# EXTERNAL MEMORANDUM

**Date:** November 21, 2022

**Subject:** Response to October 2022 DANR Comments on Wharf's Boston Expansion Large Scale Mine Permit

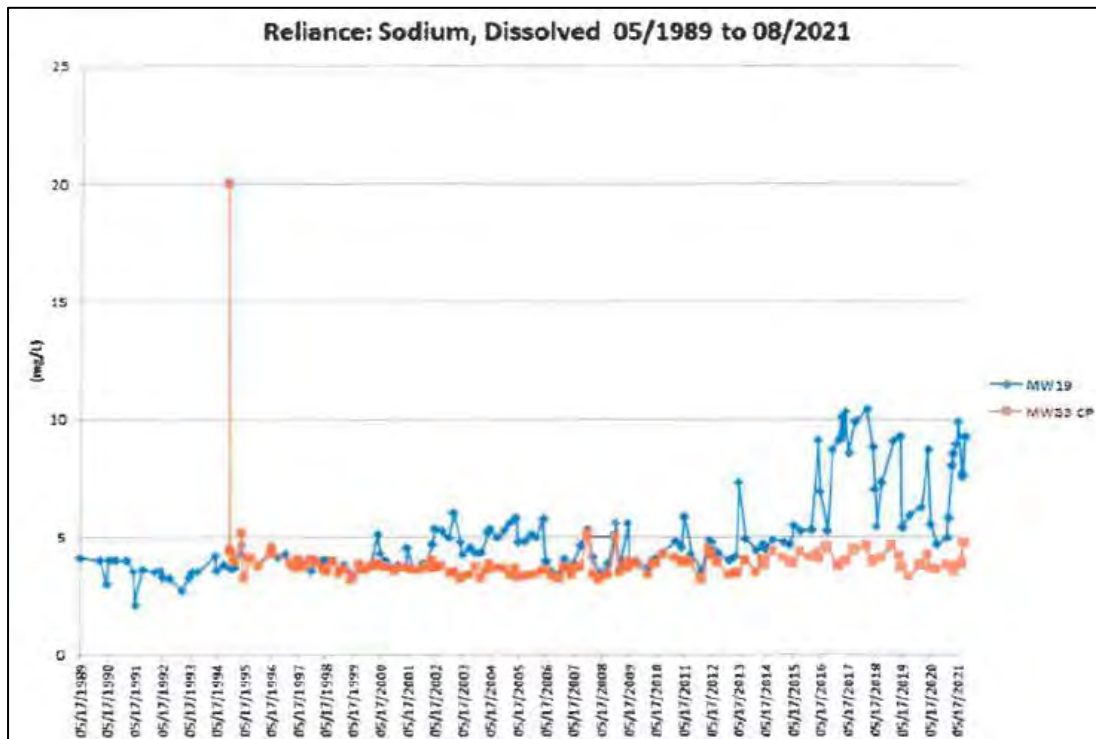
11. Photos were provided for all sound monitoring sites addressed in the Sound Baseline Survey except for SND-07. Even though the original photo was corrupted and not available, Wharf should take a photo of SND-07 and include it in the survey.

Wharf staff took a photograph of sound monitoring site SND-07 located at the intersection of Last Chance Trail and Antelope Trail as provided below. The photograph is oriented looking northwest toward the Boston Expansion.
